Sub Registrar's Office at Chettiikulam: Re-
vised estimate of Rs. 2950 for constructing a
— in Trichinopoly D^y Sanctioned.

Name of work Constructing Sub-Registrars Office at Chettikulam, Trichinopoly Dist.
Amount of estimate Rs 2950.

Approving and transferring to the P.W.D. the revised estimate aggregating Rs. 2,950 for constructing an Office building for the Sub-Registrar of Chettikulam, Trichy Dist.:

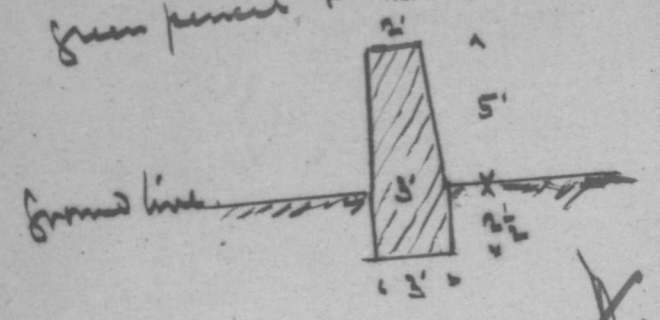
Two sections for the compound wall for the culvert have been submitted. The foundations for the compound wall have been provided for in the estimate, with detail quantities marked in green pencil. The section is thus:-

Is there no section for the compound wall or for the culvert? And for the former then seem to be no foundations provided.
